**County of Loudoun**  
**Department of Planning**

**SUBJECT: ZMAP 2010-0001 & SPEX 2010-0003,  
HS-7 Dulles South and Elementary School, 2<sup>nd</sup> Referral**

**SUBJECT: ZMAP 2010-0001 & SPEX 2010-0003,  
HS-7 Dulles South and Elementary School**

**Photograph 1: Open floodplain area adjacent to the South Fork Broad Run**

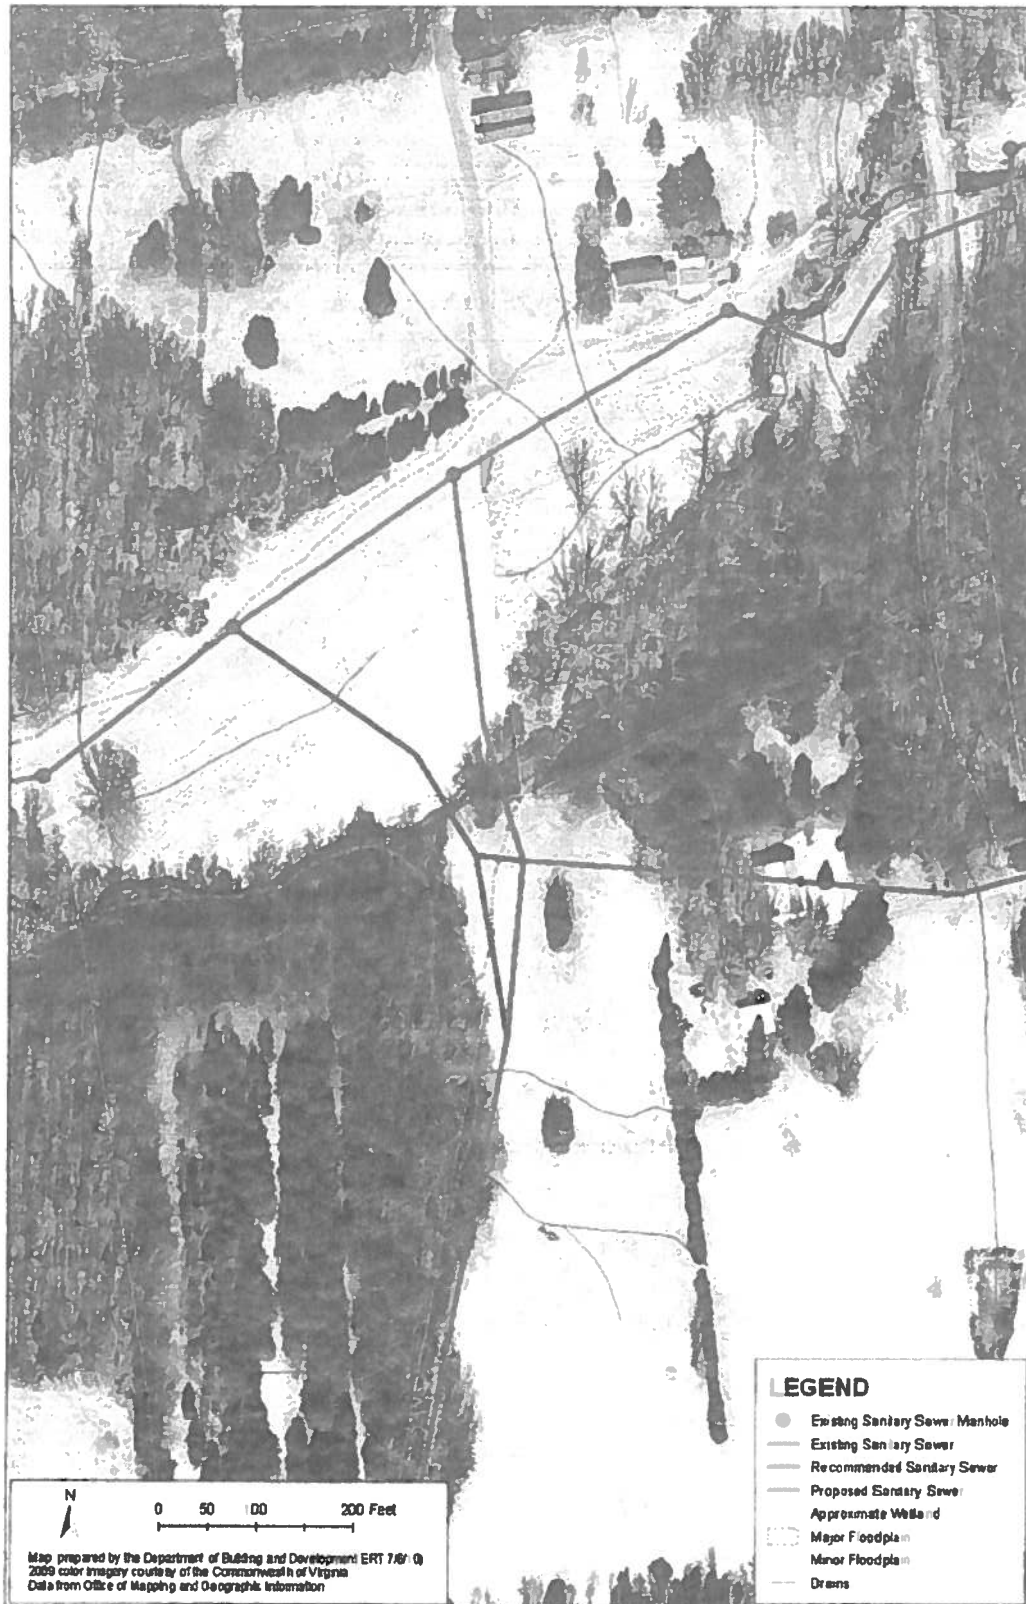
on sheets 3 (Special Exception/Rezoning Plat) and 6 (Water and Sewer Facilities Map). Attachment A and Photographs 1 and 2 identify the approximate location of the reforestation areas. Staff further recommends that a reforestation commitment be provided specifying the following: 1) the applicant shall work with the County Urban Forester on the development of the reforestation plan; 2) the reforestation plan shall be submitted to the County Urban Forester for review and approval prior to the approval of the first site plan; 3) plant material shall consist of 3-gallon containerized native trees within the floodplain and bare root seedlings with tubes outside of the floodplain; 4) the reforestation shall be implemented prior to issuance of the first certificate of occupancy; 5) the applicant shall ensure a minimum of 80 percent of the initial planting is determined to be established after two growing seasons; 6) an annual inspection shall be conducted by the applicant and the County Urban Forester to verify establishment; and 7) if the 80 percent establishment isn't achieved after the second growing season, a onetime planting to bring the project to full stocking shall be conducted by the applicant.

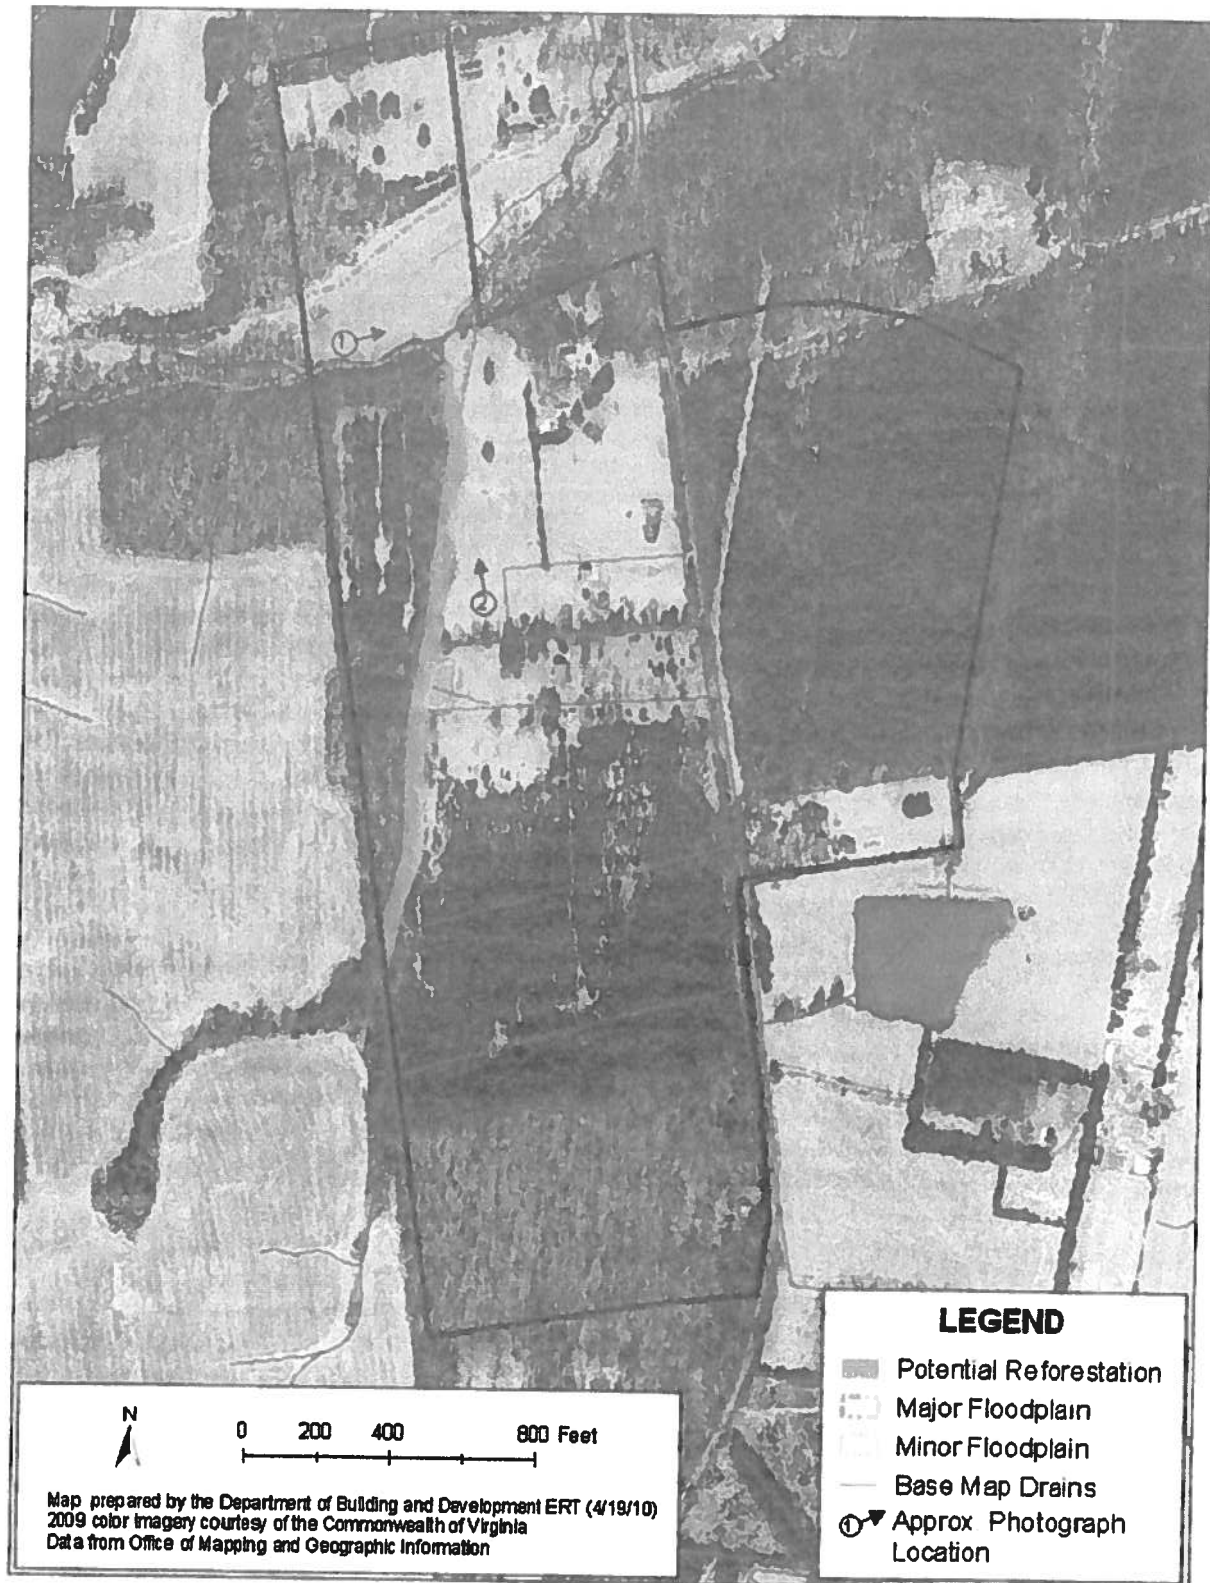
- 10) The steep slopes designation differs slightly from the Loudoun Geographic Information Systems (LOGIS) steep slopes layer. For clarity, please specify the basis for the steep slope designations on the plan set. [Revised 1993 LCZO Section 5-1508 and 6-407]
